# Access Compliance Report

## Public Rights-of-Way

### (Curb Ramps)

Intersection ID: 2755	Main Street: BELL'S_MILL_DR	Cross Street: RIDGEFIELD_DR	Location: S
ADA ID: 49F598458863	Ramp Type: Perp	Initial Pass/Fail: Fail	Overall Compliance: No
Severity Score: 22.5			
Codes/Mitigation Info/Possible Solution		Field Measurements/Component Compliance

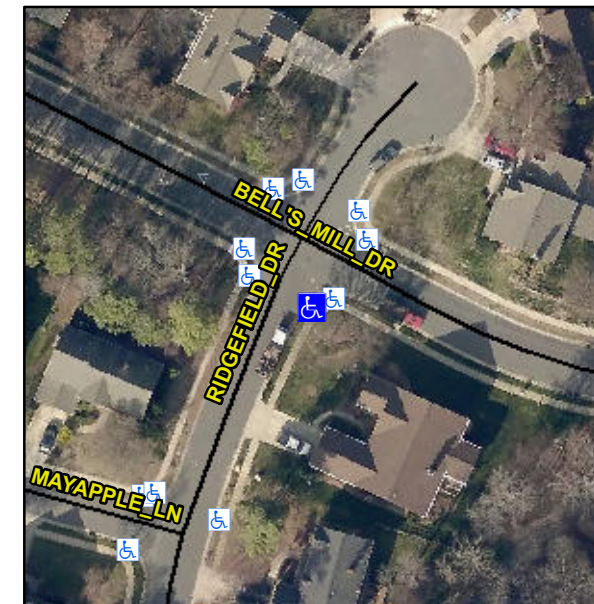
**R304.5.1, R304.2.2, R304.5.3**

Compliance	Description	Data	Compliance	Description	Data
N/A	Ramp Length (in)	50.0	No	Ramp Slope (%)	8.8
No	Ramp Width (in)	38.0	No	Ramp XSlope (%)	3.5
N/A	Flare Type LT	N/A	N/A	Flare Type RT	N/A
N/A	Flare Slope LT (%)	N/A	N/A	Flare Slope RT (%)	N/A
N/A	Flare Traversable LT?	N/A	N/A	Flare Traversable RT?	N/A
N/A	Landing Length (in)	N/A	N/A	DWS Provided?	N/A
N/A	Landing Width (in)	N/A	N/A	DWS Contrast?	N/A
N/A	Landing Slope (%)	N/A	N/A	DWS Length (in)	N/A
N/A	Landing X Slope (%)	N/A	N/A	DWS Full Width?	N/A
N/A	Landing Curb? (Y/N)	N/A	N/A	DWS Offset (in)	N/A
N/A	Shared Landing?	N/A			
N/A	Gutter Ponding?	N/A	N/A	Gutter Slope (%)	N/A
N/A	Gutter Lip Ht (in)	N/A	N/A	Gutter X Slope (%)	N/A
N/A	Painted X Walk1?	No	N/A	Painted X Walk2?	N/A
	X Walk 1 Direction	To NW		X Walk 2 Direction	N/A
N/A	X Walk 1 Width (in)	N/A	N/A	X Walk 2 Width (in)	N/A
	X Walk 1 Slope (%)	4.5		X Walk 2 Slope (%)	N/A
	X Walk 1 X Slope (%)	0.9		X Walk 2 X Slope (%)	N/A

**Remove & Replace Entire Ramp.**
